**ADDITIONAL DETERMINISTIC EVALUATIONS
PERFORMED TO ASSESS SEISMIC MARGINS
OF THE DIABLO CANYON POWER PLANT
UNITS 1 AND 2**

Diablo Canyon Power Plant
Long Term Seismic Program

PREFACE

PG&E's response to the NRC Staff's April 1990 request for additional information regarding the Diablo Canyon Long Term Seismic Program deterministic evaluations is contained in this volume. The reply to the request is included in the responses to nine questions we have formulated to best describe the additional deterministic evaluations performed to augment the information contained in Chapters 7 and 8 of the Long Term Seismic Program Final Report. The NRC Staff's general request precedes Question DE 1.

Figure DE Q2-1

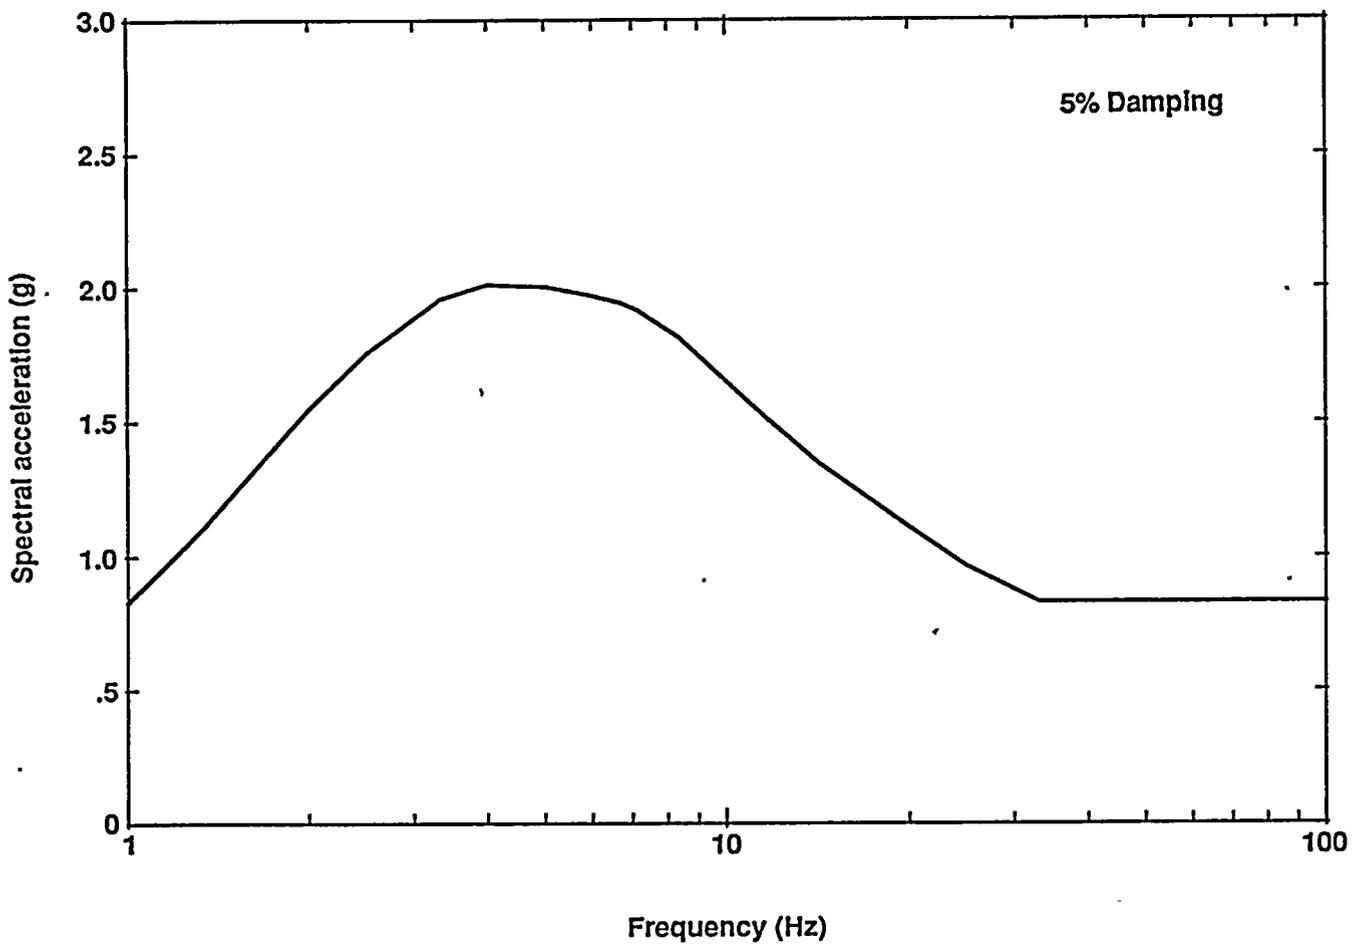
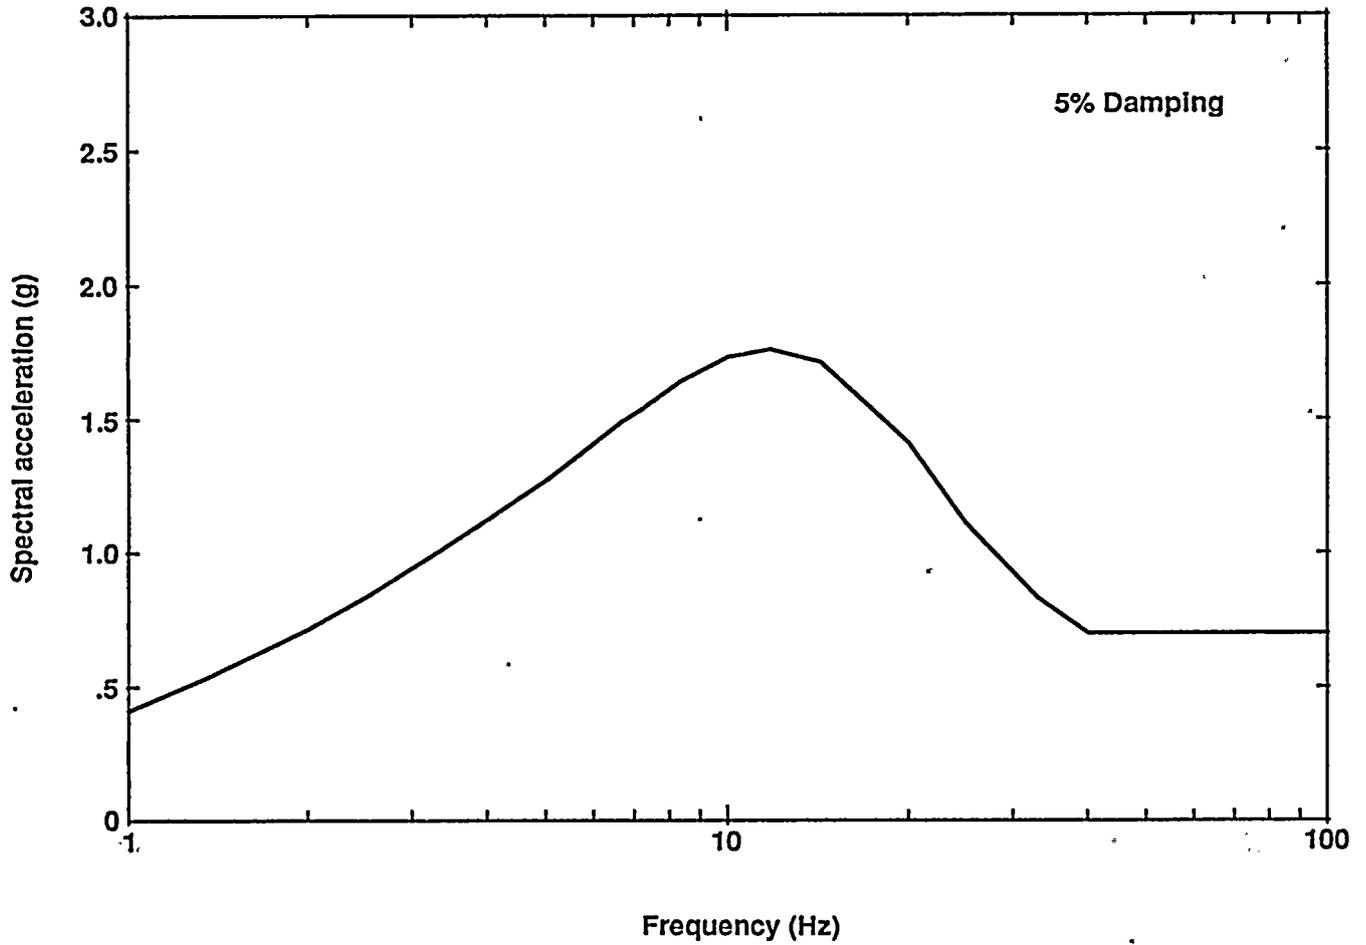
Describe the seismic ground motions that were used for the additional deterministic evaluations of the Plant structures.

The seismic ground motion input data were the 84th-percentile, 5 percent damped, horizontal and vertical site-specific acceleration response spectra defined in the Diablo Canyon Long Term Seismic Program Final Report (PG&E, 1988) for the maximum magnitude earthquake. These spectra are shown in Figures DE Q2-1 and DE Q2-2.

Figure DE Q4-1

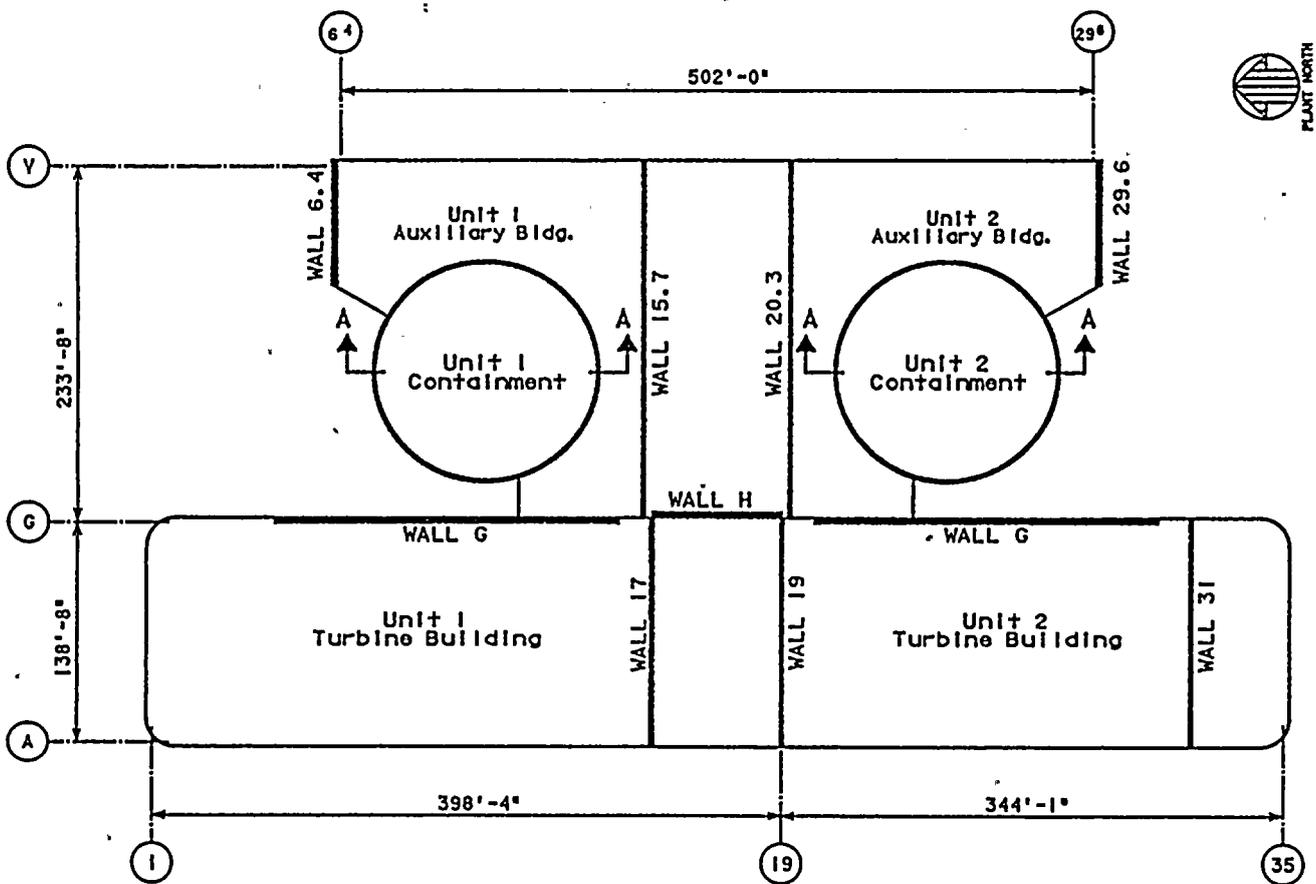
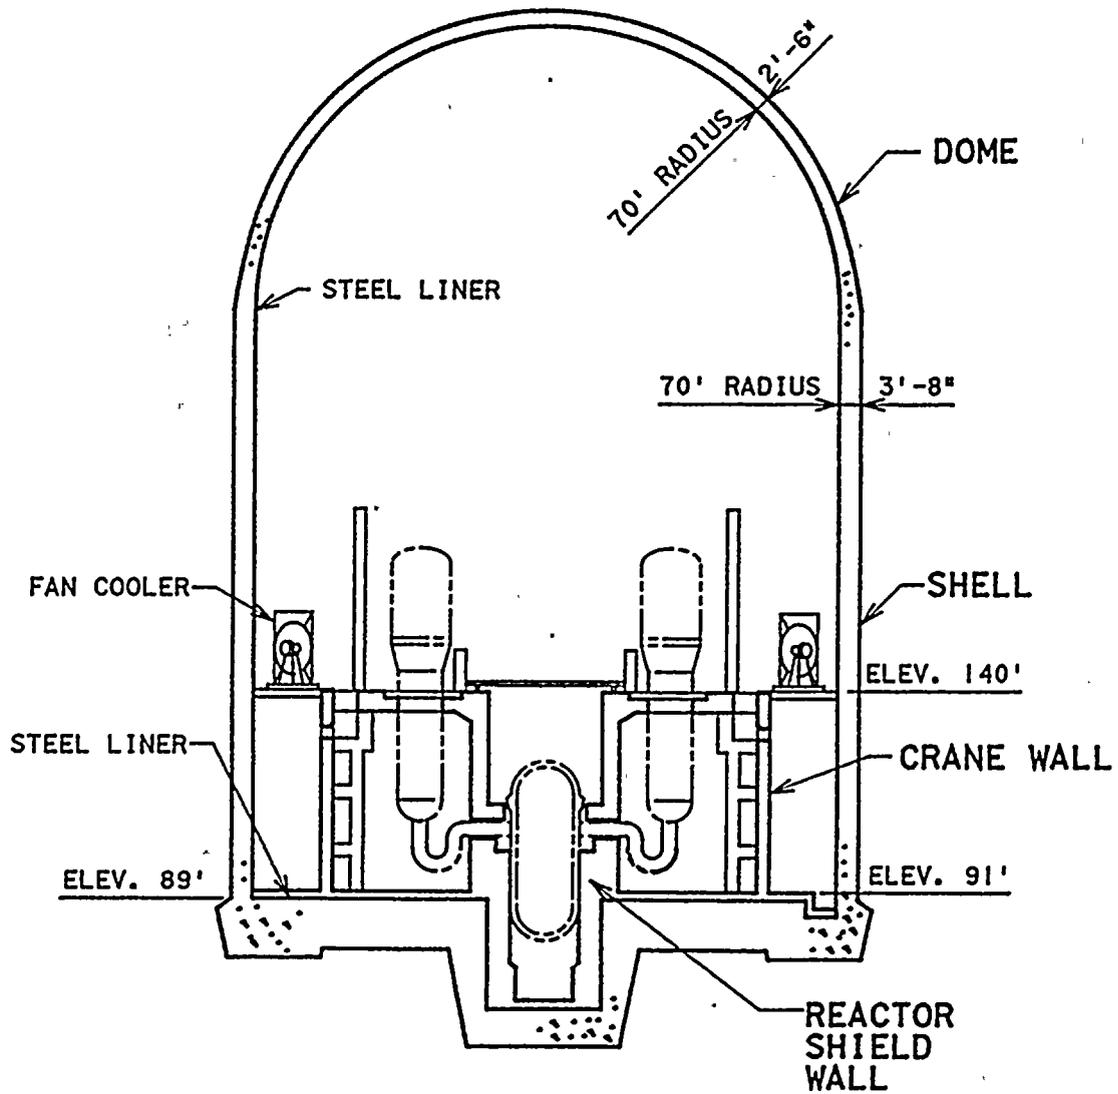
Compare the seismic base shear and overturning moments in the containment, auxiliary, and turbine buildings due to the maximum magnitude earthquake with the corresponding seismic responses determined using the Hosgri reevaluation criteria. The comparisons should be provided for the global structure and for selected structural elements in each building.

Figure DE Q4-1 shows the configuration of the Plant power block structures. The figure also identifies the structural elements in the auxiliary and turbine buildings for which additional deterministic evaluations were performed. The structural elements examined for the containment building were the exterior shell and the concrete interior structure, which includes the crane wall and the reactor shield wall. As shown in Figure DE Q4-2, these structural elements are cylindrical, reinforced concrete walls supported on a common basemat at elevation 89 feet. While there are several walls that comprise the concrete interior structures, the crane wall and the reactor shield wall are the major lateral force resisting elements. Table DE Q4-1 shows the shear forces, overturning moments, and torsional moments at the base of the containment shell and the interior structure for the 84th-percentile ground motion for the maximum magnitude earthquake and the Hosgri reevaluation. The forces and moments at elevation 172 feet of the containment shell are also provided. The inclined reinforcing bars near the inner face of the shell terminate at this location. Table DE Q4-1 also includes Hosgri shear force and moment capacities of the containment shell and interior structure.

The turbine building shear walls at column lines 17, 19, 31, and G (Figure DE Q4-1) were evaluated. Wall 17 is the most critical east-west shear wall of Unit 1. Walls 19 and 31 are the two major shear walls of Unit 2 in the east-west direction. Wall G is one of the two north-south shear walls of the structure and was identified as the critical north-south wall for the Hosgri reevaluation. Table DE Q4-3 shows the shear forces and moments at selected sections of these walls for the maximum magnitude earthquake and the Hosgri reevaluation. The table shows seismic demand forces only. In general, the maximum magnitude earthquake demands are higher than the Hosgri demands. The response to Question DE 6 shows that the maximum magnitude earthquake demands can be accommodated by the capacities

Figure DE Q6-A-1

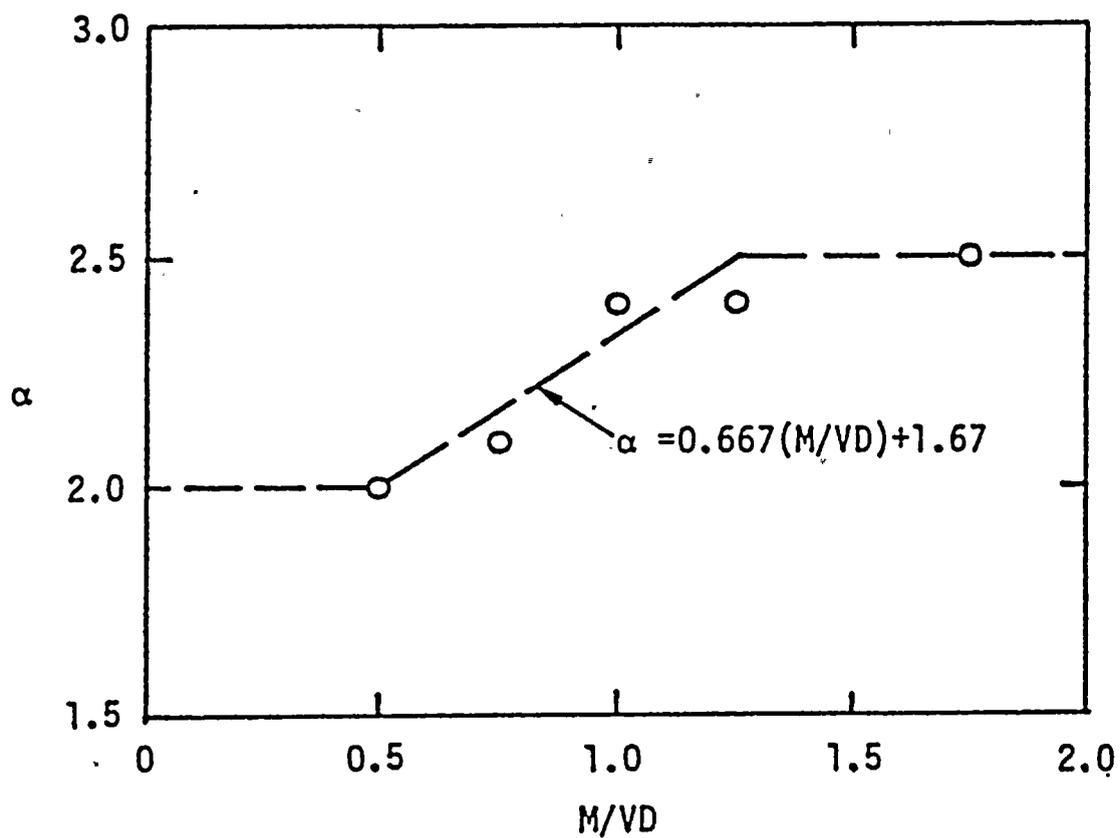
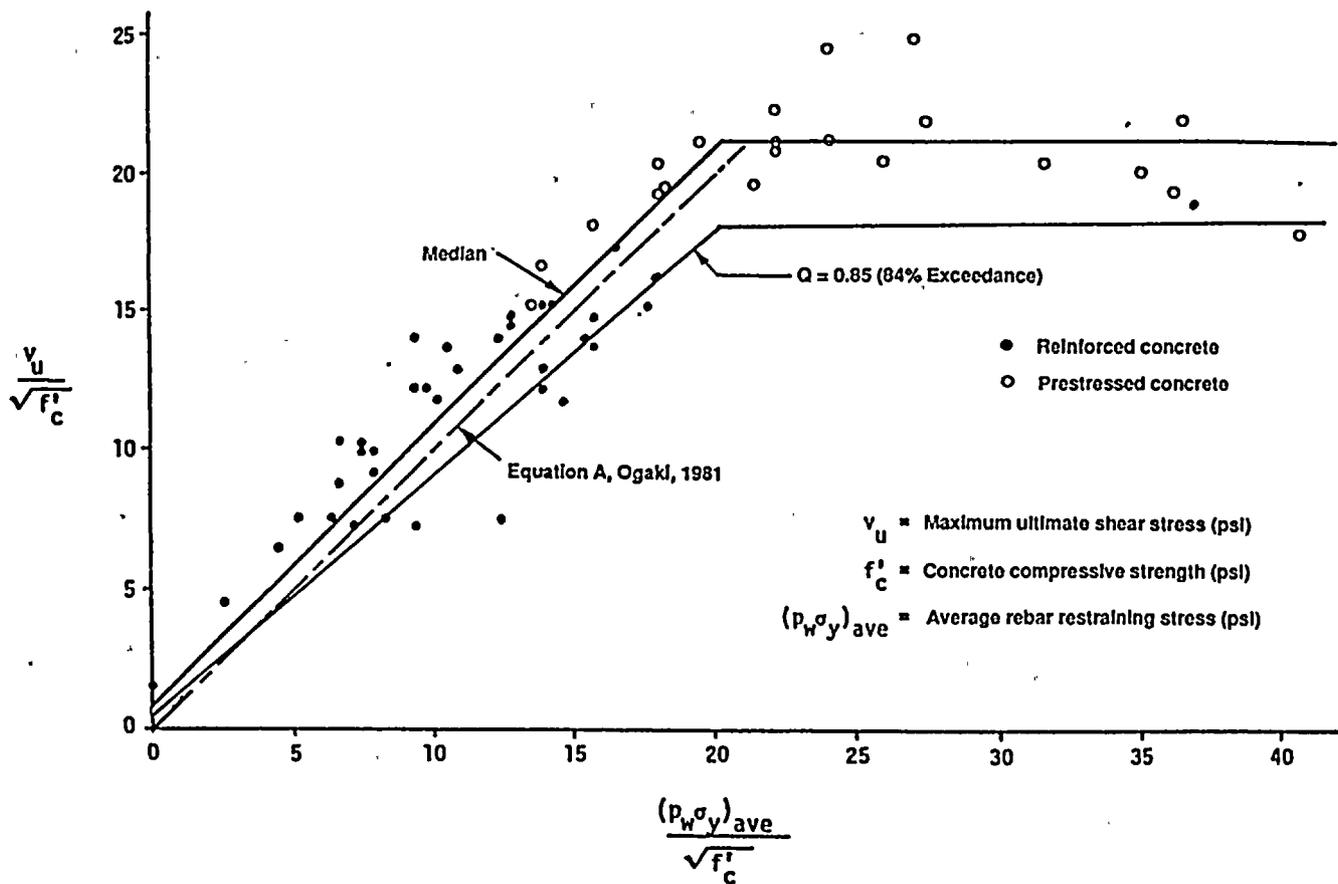
Evaluate the capacities of structural elements using the conservative deterministic failure margin (CDFM) approach. Compare the loads in the structural elements due to the maximum magnitude earthquake with the corresponding CDFM capacities. Establish the seismic margins in the structural elements selected for evaluation.

Based on inelastic finite element stress analysis, Ogaki, 1981 shows α to be a function of the ratio of the moment to the product of the shear and the cylindrical diameter ($M/V D$), as shown in Figure DE Q6-A-1. For ($M/V D$) ratios less than or equal to 0.5, $\alpha = 2.0$ is commonly used. However, as ($M/V D$) is increased, α is increased, reaching $\alpha = 2.5$ for ($M/V D$) of 1.25 or greater.

As shown in Figure DE Q6-A-2, a median estimate of v_u is given by:
